St. John Street Garage Site Plan Application Responses to Public Comments

August 2018

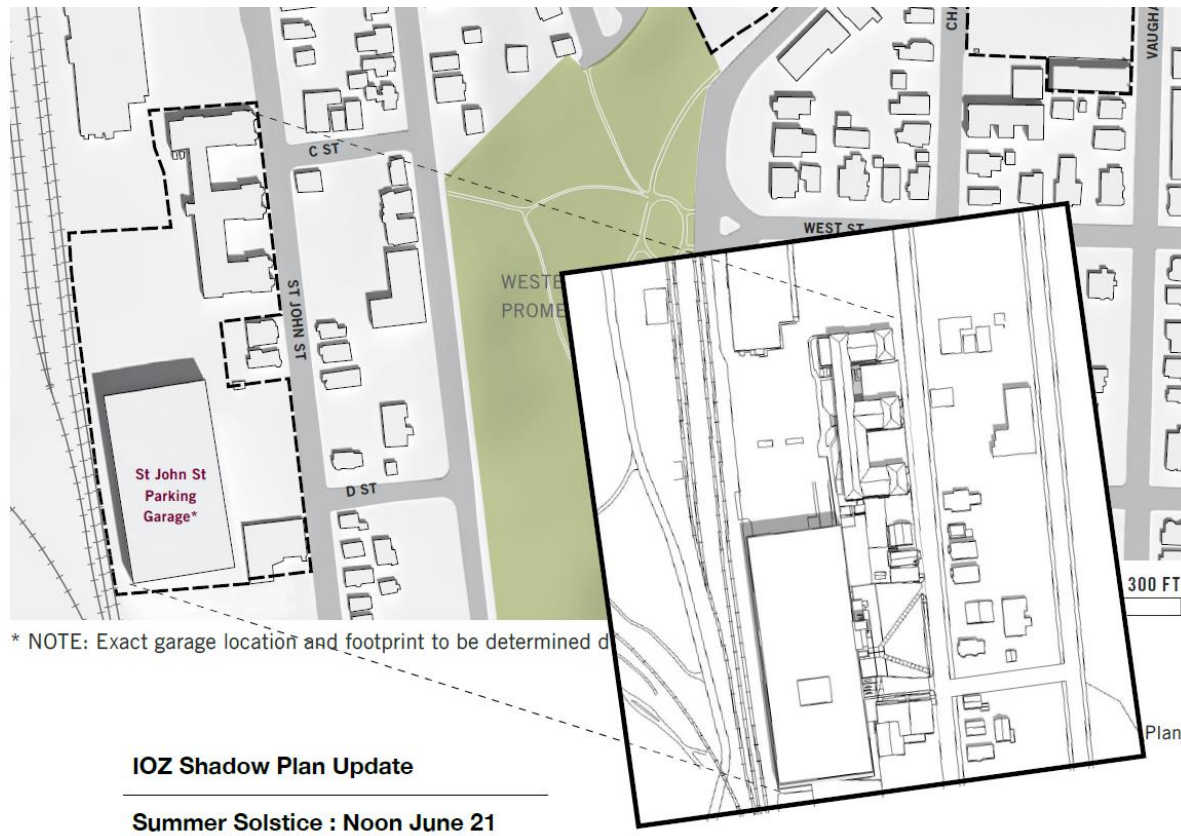
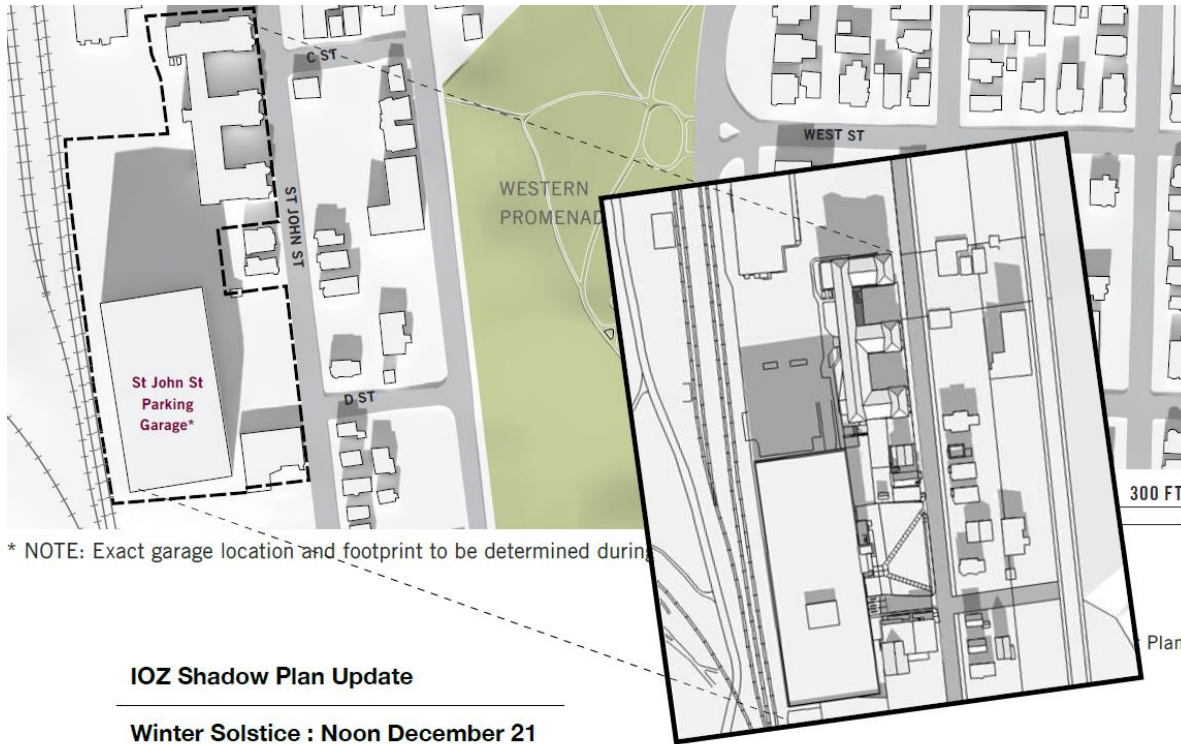
“I think further discussion of the renderings would also be helpful. I see from the site plan that the elevation of the parking lot is around El. 26. The building is to be just under 100 ft. tall, putting the top of the building somewhere around El. 125. Also from the site plan, the elevation of the yard at 210 St. John St. is around El. 42 and the building is about 33 ft. tall, putting the ridge of the roof at around elevation 75. This means that the parking garage exceeds the height of the top of 210 St. John St. roof by 50 ft. – five stories! I don’t know the height of the Railroad Building, but say it’s 50 ft. This means the top of the Railroad Building is around El. 90 and parking garage exceeds it by 35 ft. – approximately as if 210 St. John St. were put on top of the Railroad Building. I just don’t think the renderings reflect how high the garage is proposed to be.”

The building was designed to fit within the building envelope defined in the Institutional Overlay Zone (See attachment 1, Section 4, Map 4.1 of the IDP). Removing street trees from all views would not change the perspective of the garage and its relationship to the surrounding buildings.

Attachment 2: Updated Shadow Studies

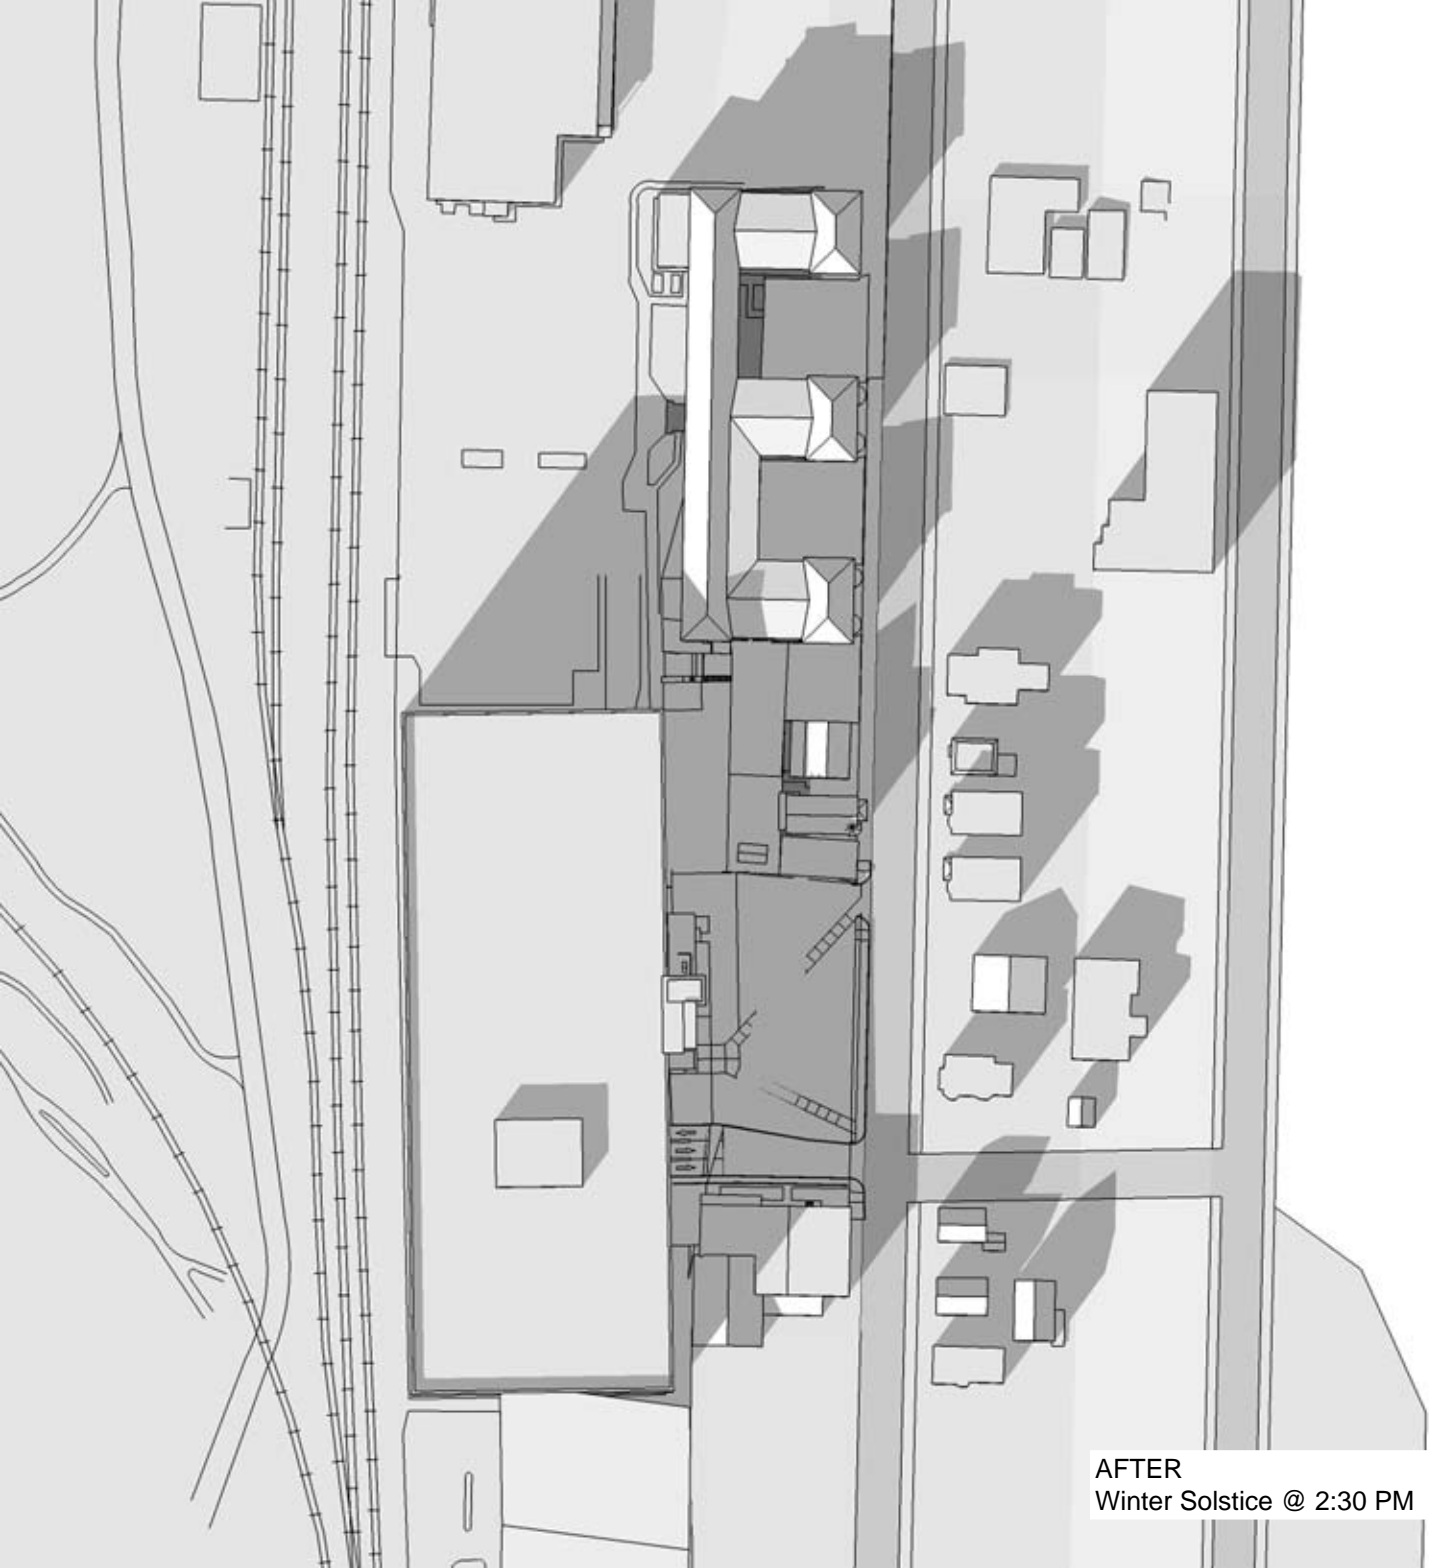
"I looked at the shadow studies in the Institutional Development Plan and notice that the location and size of the garage is now changed. I realize MMC was limited to static images in the printed document, but a static image does not convey the changes in sunlight and shadow through different day lengths, sun angles, seasons, etc. I would like to see continuous motion studies of full days on all four solstice dates at least."

Response: The garage design was not complete when the IDP was finalized. The dimensions of the building used in the shadow study are different than what is proposed. There is a footnote in the IDP Fig 5.18 and 5.20 that states "Note: exact garage locations and footprint to be determined during detailed design." See attachment 2 for updated shadow studies.
